Reference: Response to May 31, 2011 UNC North Comments Received  
SAW-2010-01840  
Individual Permit Application for Carolina North Project  
The University of North Carolina at Chapel Hill  
Orange County  
North Carolina

On May 31, 2011, the United States Army Corp of Engineers (USACE) provided the University of North Carolina at Chapel Hill (UNC-CH or University) the public comments resulting from the USACE Public Comment period (April 8 through May 9, 2011) for the UNC-CH Carolina North Individual Permit Application. Below are the comments in italics followed by the University's responses to those comments.

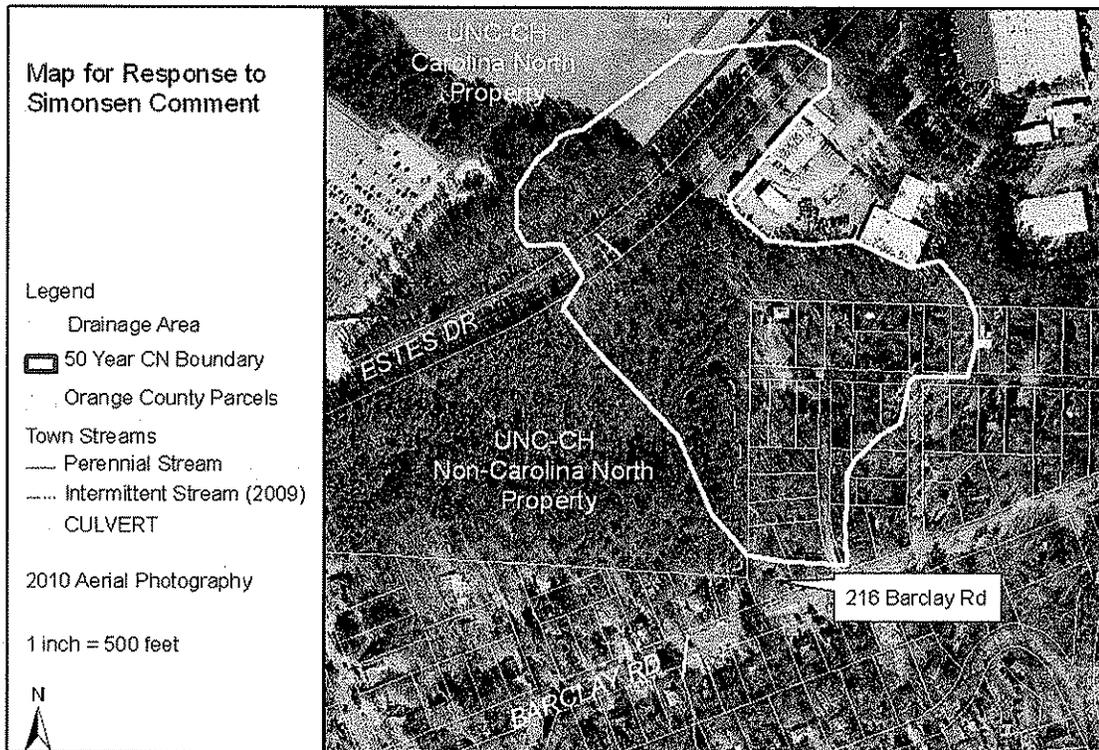
- 1. Simonsen Comment re: Stormwater and Flooding Issues: Mr. Simonsen stated "I don't know if you can do anything about the situation at the southern end of the Airport property. My wife and I own KALAMANI and the property at 216 Barclay Rd. The university and the town of Chapel Hill appear to drain a lot of water down toward our property so as to completely flood the property at times."*

**UNC Response to Simonsen Comment:** Mr. Simonsen's property is located at a low point where stormwater run-off forms a stream that has been identified and mapped by the Town of Chapel Hill (TOCH) Stormwater Management Division as an intermittent stream. The Carolina North (CN) development will not increase the run-off to Mr. Simonsen's property.

Where the intermittent stream formed by stormwater run-off crosses the property, the stream's drainage area is approximately 20 acres and is composed of: forested University property south of Estes Drive that is not part of the Carolina North (CN) Project (40%); residential area and residential streets (30%); CN property (20%); and Estes Drive North Carolina Department of Transportation (NCDOT) right-of-way (10%).

As part of the CN Development Agreement (DA), the University is required to meet stormwater management criteria that address the volume and peak flow of runoff

from each point where stormwater runoff leaves the CN property. These criteria prevent additional runoff from impacting downstream properties. For each Site Development Permit (SDP) at CN, the TOCH Stormwater Management Division will review the University's stormwater plans and calculations for compliance with the stormwater management criteria.

We have also referred Mr. Simonsen's comments to the TOCH's Stormwater Management Division.
